Cub Cadet

Service Bulletin

CC-310

Subject: PTO Clutch Relay

1. 725-1648 PTO Relay
2. 721-0342 Silicone Gasket
3. Plug on Electrical Harness

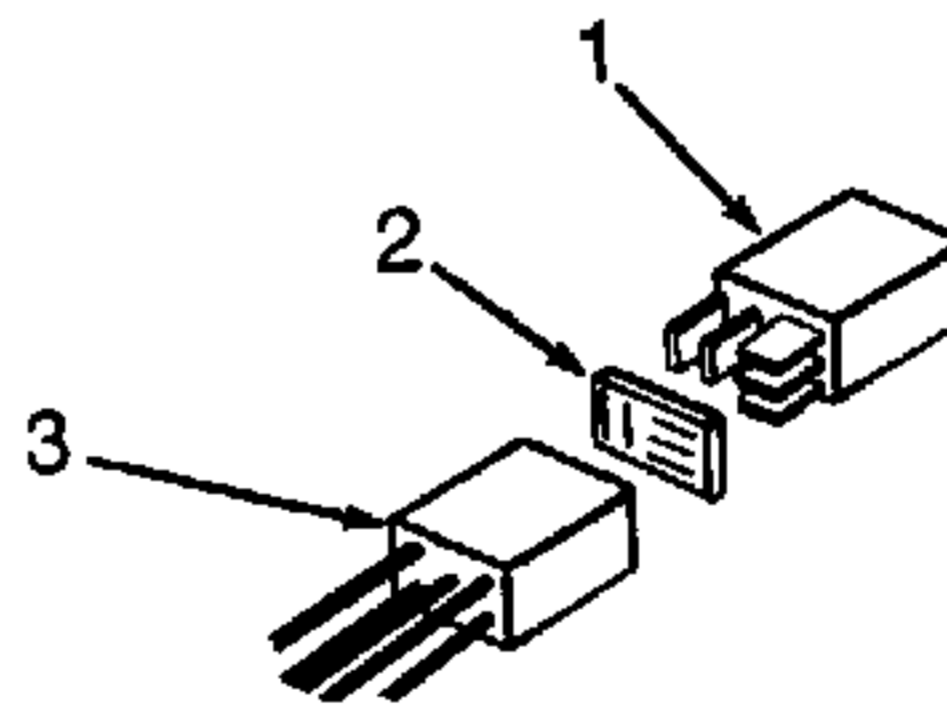
Problem: Field reports indicate the Series 2000 tractor may experience the PTO clutch not engaging when the PTO switch is in the run position. The failure cause has been identified as the 725-1648 PTO relay (1). Further investigation usually reveals that the 721-0342 silicone gasket (2) was missing between the Hella brand relay and the plug (3) on the electrical harness. Moisture enters around the plug of the relay and can cause the relay to become corroded or shorted.

Solution: When replacing PTO relay located beneath the instrument panel, always use a silicone gasket as shown below. Some Series 2000 tractors used in production a Bosch brand PTO relay which does not require a silicone gasket. All current production Series 2000 tractors will use a silicone gasket regardless of brand.

Note: Silicone gasket is not included with PTO relay from service parts.
